PARKING ANALYSIS

SADDLE ROCK CROSSING

REVISED 31 JULY 2024

**Saddle Rock Crossing PA
Dated 13 September 2021
Comment Resolution**

SITE PLAN
1"=30'-0"
0 30 60 90

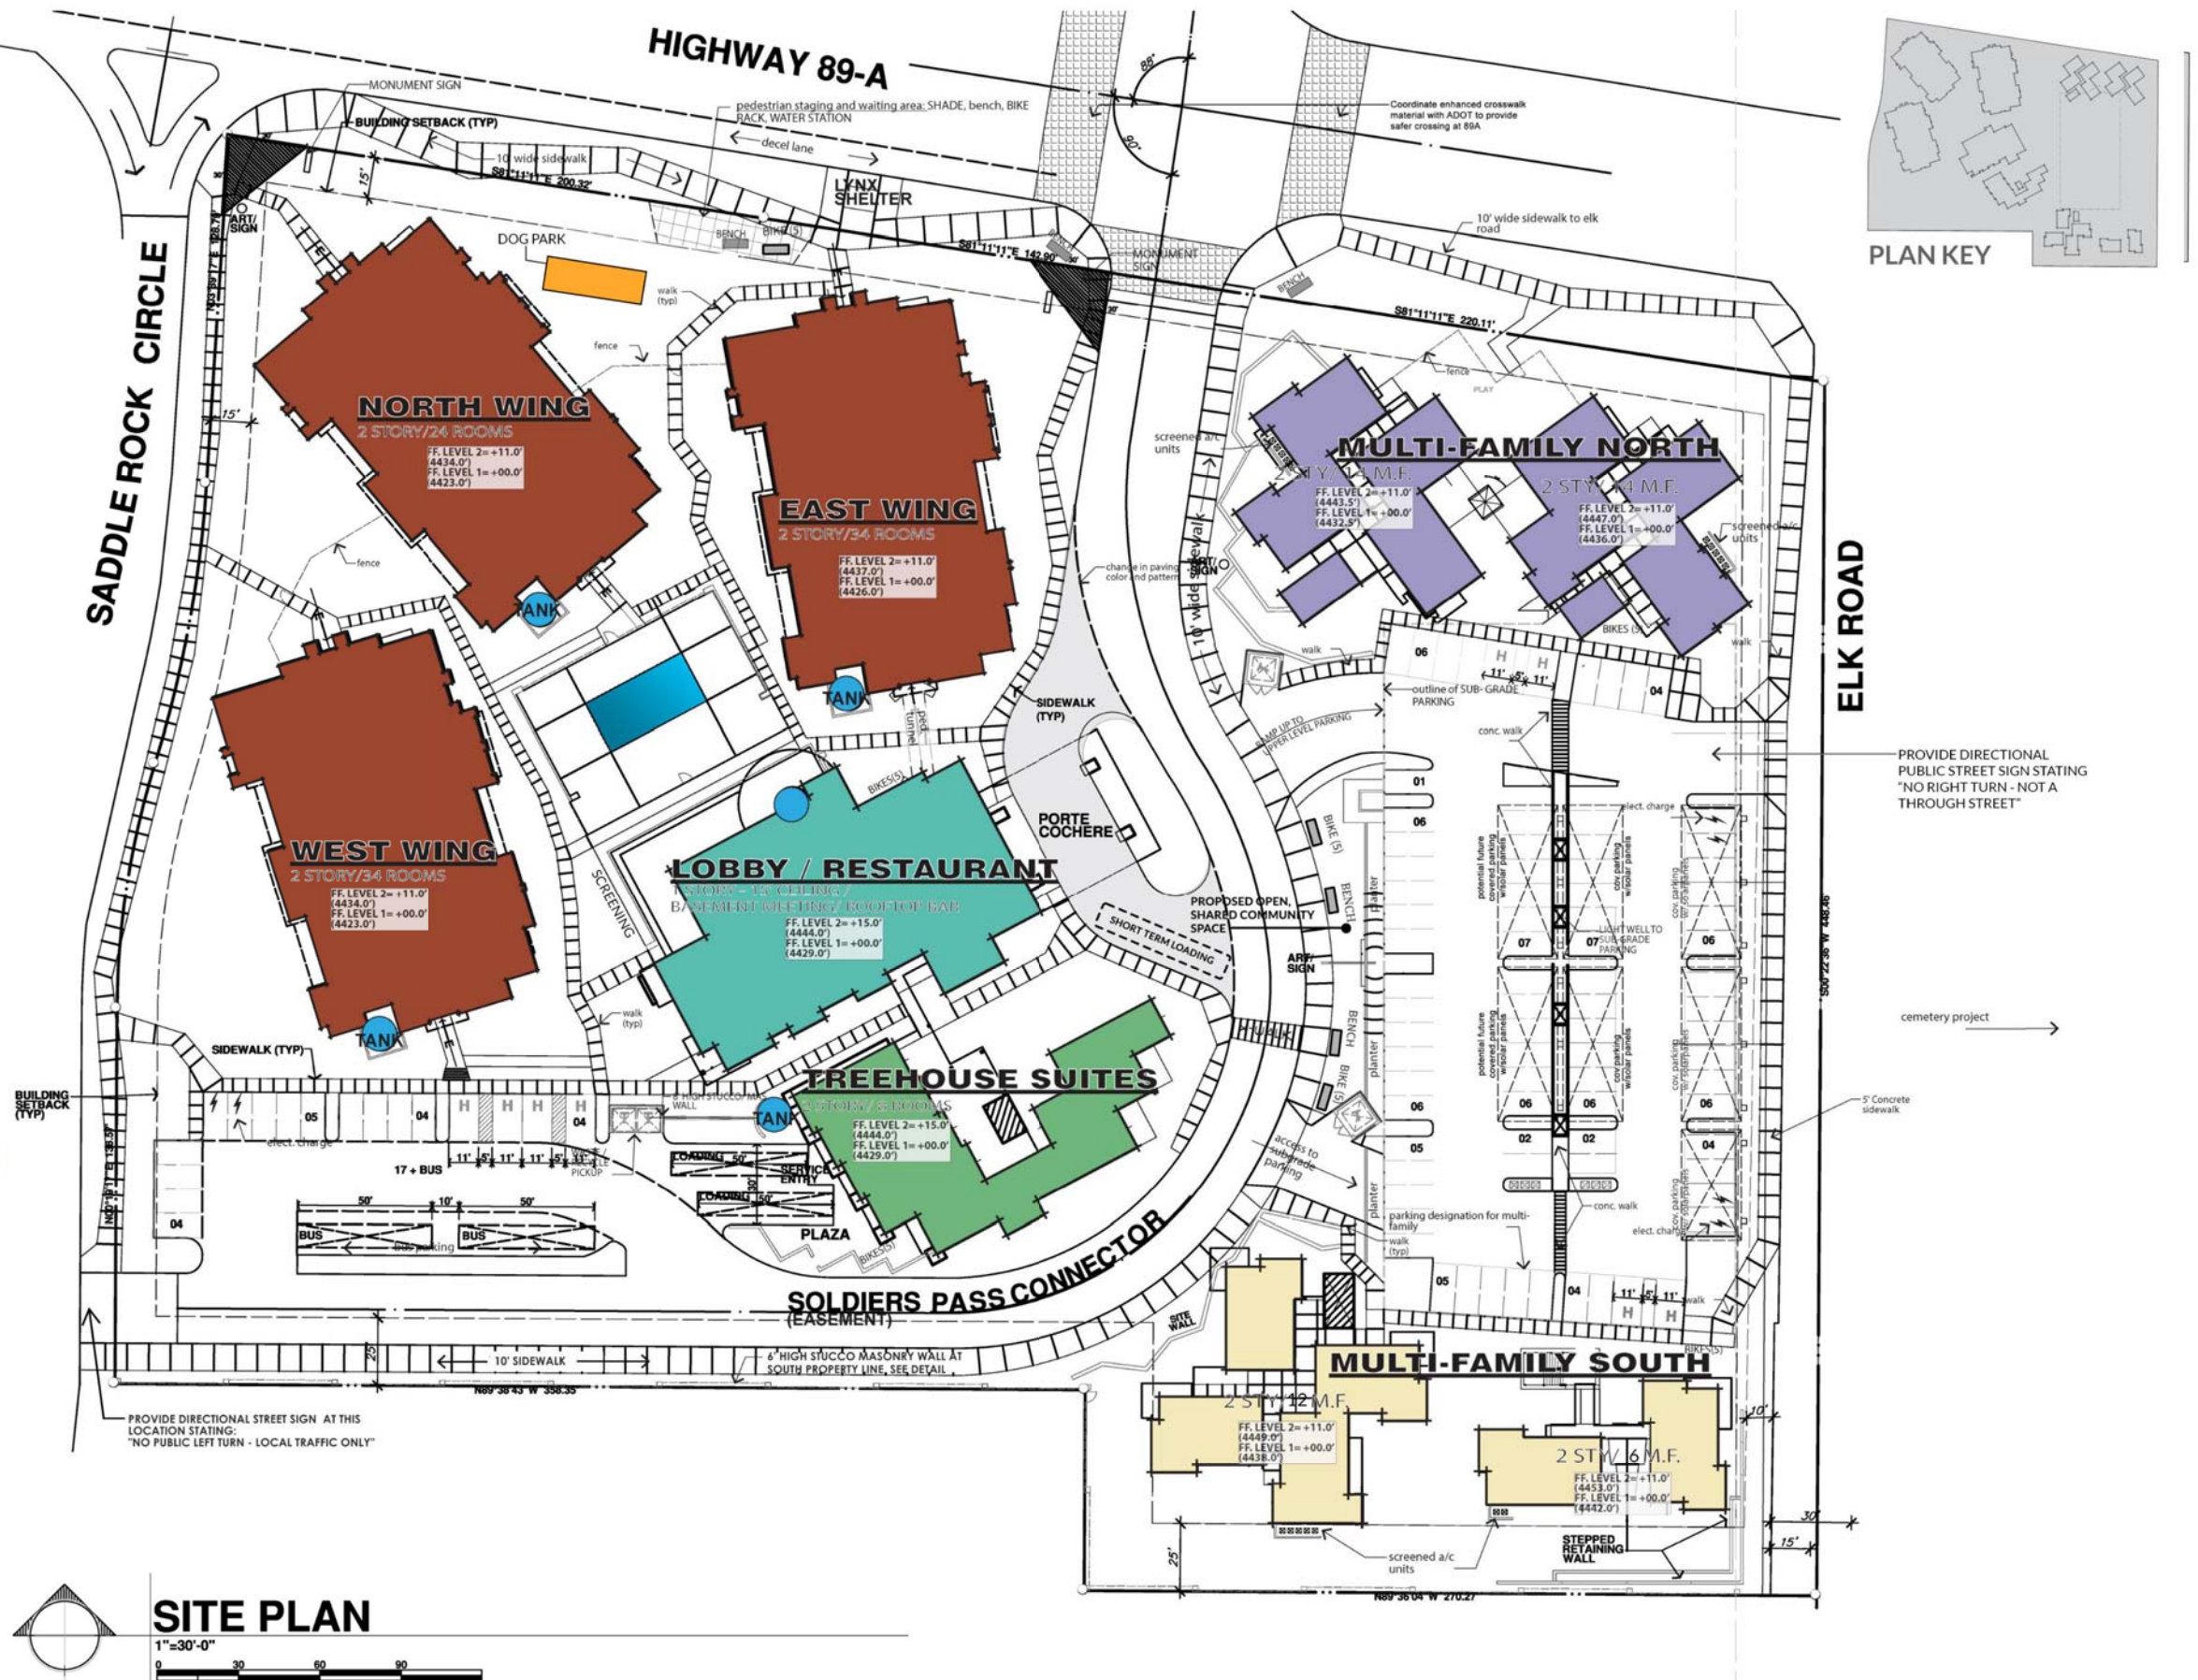
Item No.	Page No.	Reviewer	Code	Comment	Response
City of Sedona					
1	General Comment	Sedona	D	The parking summary and parking study state that 210 parking spaces are provided (177 in parking structure, 21 in surface lot, and 2 bus spaces - counting for 12 spaces). The plans show a total of 198 spaces (165 in parking structure, 21 in surface lot, and 2 bus spaces - counting for 12 spaces). The conclusion of the parking analysis states 125 spaces will be in the structure. Amend appropriate documents so all project components show the same amount of parking being provided.	See revised report.
2	General Comment	Sedona	D	If an accessory use (restaurant, conference center) is 100% used by guests, the parking requirement cannot be "0", as additional staff would be needed for these uses.	The restaurant is expected to mostly be used by hotel guests in the morning. See revised calculation sheet (and report) for employee parking during this time.

9	General Comment	Sedona	A	Parking calculations based on area shall be based on gross square footage. Ensure gross area, including restrooms, circulation, etc., are included in parking calculations.	See revised report.
10	General Comment	Sedona	A	Indicate location of bicycle parking on plans. Bicycle parking is required at a rate of 1 bike parking space per 10 vehicle parking spaces. See LDC Section 5.5.D(3) for standards for bicycle parking. Bicycle parking should be provided throughout the site so it is convenient to users of both the multifamily units and hotel.	See revised site plan.
11	General Comment	Sedona	A	Loading spaces are required (LDC 5.5.G). Show location. In addition, the project should anticipate trolleys, jeeps, and/or other tours needing space for pick up/drop off.	See revised site plan.
12	General Comment	Sedona	A	Please offset parking spaces that are at a 90 degree angle to each other to prevent trapping vehicles.	See revised site plan.
